Document: JPA Post-submittal Meeting Minutes

Project	Hampton Roads Bridge-Tunnel Expansion
Meeting Title	Joint Permit Application Post-Submittal Meeting
Date Time	October 1, 2019; 10:00 AM
Location	DoubleTree Hotel, Norfolk VA Conference Room/Ballroom D
Call In Number

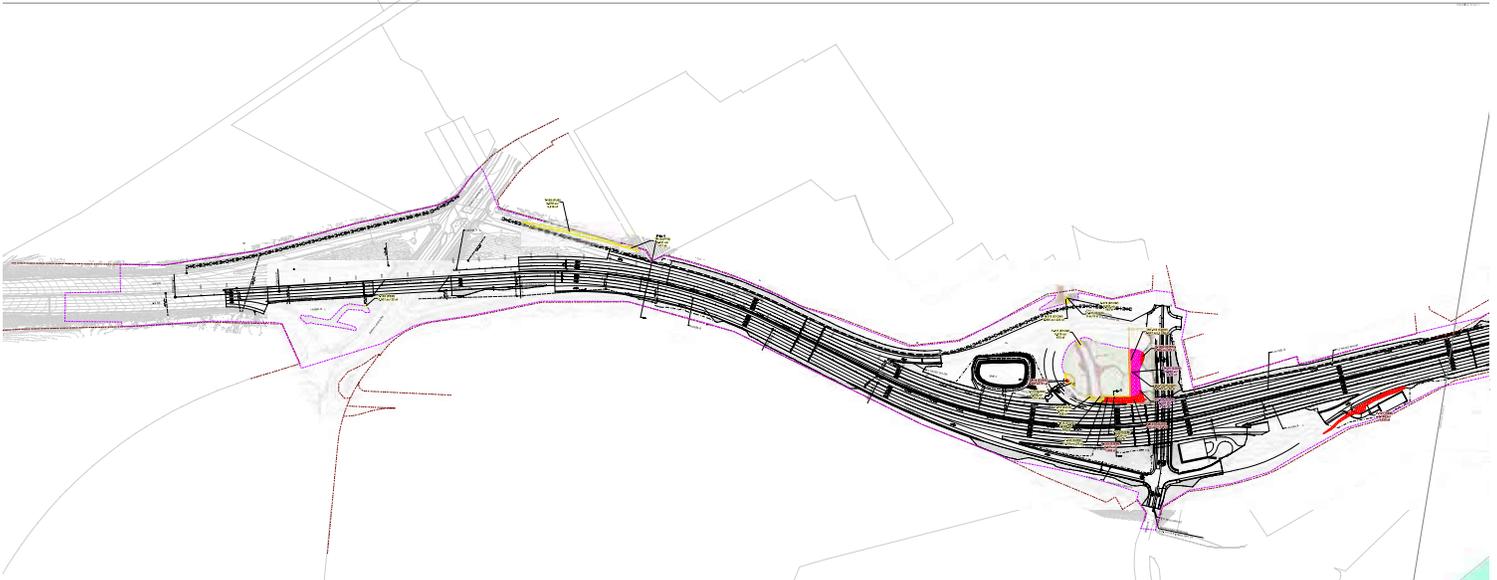
<p>Location T-150</p>	<p>This is the outlet to a culvert. HRCP plans to do field inspection of culverts prior to work. May be able to refine impact. J. Hannah stated that we need to maintain existing flow. GJ stated that he was OK with habitat modifications to the PJD and that they only need to be brought to his attention with the JPA information</p>	<p>HRCP - Field confirm condition of location T-150/P-150 and E10W classification.</p>
